Tender No.: T17-17 – St. Elizabeth Seton CS Child Care Expansion Durham Catholic District School Board

ADDENDUM #2

November 14, 2017

ASK-01

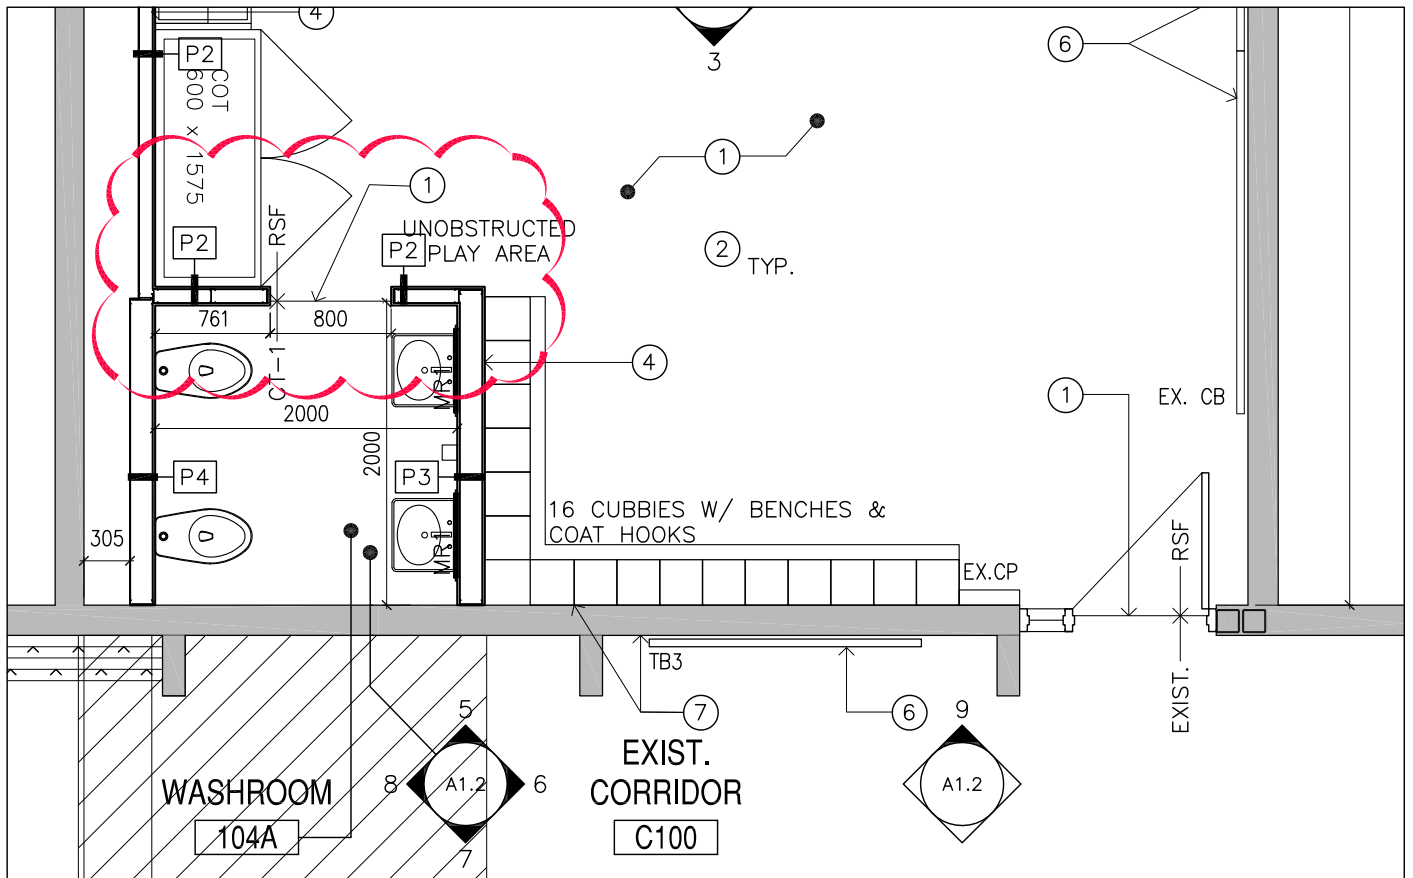
- .1 **Revise** Wall Partitions 'P1' to be revised to 'P2' as shown on ASK-01 (attached)
- .2 **Revise to Read** *Floor Plan Construction Notes:*
3 – Reserved.

- ① PROVIDE NEW RSF FLOOR FINISH & RUBBER WALL BASE TO ENTIRE NEW PRESCHOOL AREA 104. PROVIDE TRANSITION STRIPS WHERE REQUIRED. REFER TO ROOM FINISH SCHEDULE AND SPECIFICATIONS.
- ② PATCH & MAKE GOOD ALL WALLS, PREP FOR NEW PAINT FINISH. REFER TO ROOM FINISH SCHEDULE.
- ③ RESERVED
